# Access Compliance Report

## Public Rights-of-Way

### (Pedestrian Signals)

Intersection ID: N/A	Main Street:	Cross Street: N/A	Location: N/A
ADA ID: 590363A17A86	Signal Type: One Push Button-Non APS	Overall Compliance: No	Severity Score: BTN 1: N/A BTN 2: N/A No BTN: N/A
Codes/Mitigation Info/Possible Solution		Field Measurements/Component Compliance

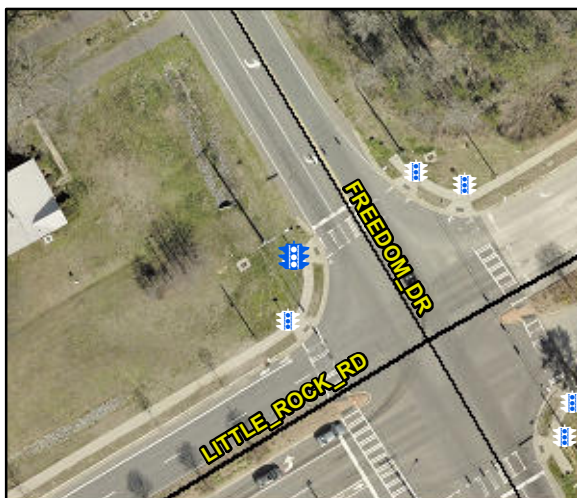
PROW/ADA: TMUTCD 4e.08, R404.2, R404.3, R404.7.2

Compliance	Description	Data	Compliance	Description	Data
	Button Count	Button1	Yes	Distant to Additional Button (in)	370.0
	Additional Button Present?	Yes		Additional Button ID	37DEDCA49A0A
N/A	Signal Buttons Required?	N/A	N/A	Additional Ped Posts Required	N/A
	How Many Ped Street Xings?	N/A		Located In An Island/Median?	N/A
N/A	B 1 Sign Present?	Yes	N/A	B 2 Sign Present?	N/A
Yes	B 1 Sign Purpose?	Yes	N/A	B 2 Sign Purpose?	N/A
Yes	B 1 Sign Lettering & Contrast?	Yes	N/A	B 2 Sign Lettering & Contrast?	N/A
Yes	B 1 Parallel To XWalk?	Yes	N/A	B 2 Parallel To XWalk?	N/A
Yes	B 1 PAR to Button?	Yes	N/A	B 2 PAR to Button?	N/A
Yes	B 1 PAR to XWalk?	Yes	N/A	B 2 PAR to XWalk?	N/A
Yes	B 1 Clear Floor Space?	Yes	N/A	B 2 Clear Floor Space?	N/A
N/A	B 1 FWD Approach?	No	N/A	B 2 FWD Approach?	N/A
N/A	B 1 FWD Approach Constrained?	N/A	N/A	B 2 FWD Approach Constrained?	N/A
N/A	B 1 FWD Approach Reach (in)	N/A	N/A	B 2 FWD Approach Reach (in)	N/A

N/A	B 1 FWD Approach Width (in)	N/A	N/A	B 2 FWD Approach Width (in)	N/A
N/A	B 1 FWD Approach Obstruction?	Yes	N/A	B 2 FWD Approach Obstruction?	N/A
N/A	B 1 FWD Approach Obstruction Dist (in)	5.0	N/A	B 2 FWD Approach ObstructionDist (in)	N/A
N/A	B 1 PARA Approach?	Yes	N/A	B 2 PARA Approach?	N/A
N/A	B 1 PARA Approach Constrained?	Yes	N/A	B 2 PARA Approach Constrained?	N/A
Yes	B 1 PARA Approach Reach (in)	5.0	N/A	B 2 PARA Approach Reach (in)	N/A
No	B 1 PARA Approach Width (in)	48.0	N/A	B 2 PARA Approach Width (in)	N/A
N/A	B 1 PARA Approach Obstruction?	Yes	N/A	B 2 PARA Approach Obstruction?	N/A
N/A	B 1 PARA Approach Obstruction Dist (in)	6.0	N/A	B 2 PARA Approach ObstructionDist (in)	N/A
No	B 1 Clear Floor Space Slope (%)	3.8	N/A	B 2 Clear Floor Space Slope (%)	N/A
No	B 1 Clear Floor Space XSlope (%)	6.9	N/A	B 2 Clear Floor Space XSlope (%)	N/A
N/A	B 1 PAR Slope (%)	N/A	N/A	B 2 PAR Slope (%)	N/A
Yes	B 1 Height (in)	36.0	N/A	B 2 Height (in)	N/A

N/A	B 1 Clear Xing Direction?	Yes	N/A	B 2 Clear Xing Direction?	N/A
	B 1 Crossing Direction	To NE		B 2 Crossing Direction	N/A
Yes	B 1 DistanceTo XWalk (in)	0.0	N/A	B 2 DistanceTo XWalk (in)	N/A
No	B 1 DistanceTo Curb (in)	132.0	N/A	B 2 DistanceTo Curb (in)	N/A
Yes	B 1 Diameter (in)	2.0	N/A	B 2 Diameter (in)	N/A

Possible Solutions: Replace Signal Push Button With APS Button on New Post. Remove & Relocate Sign.
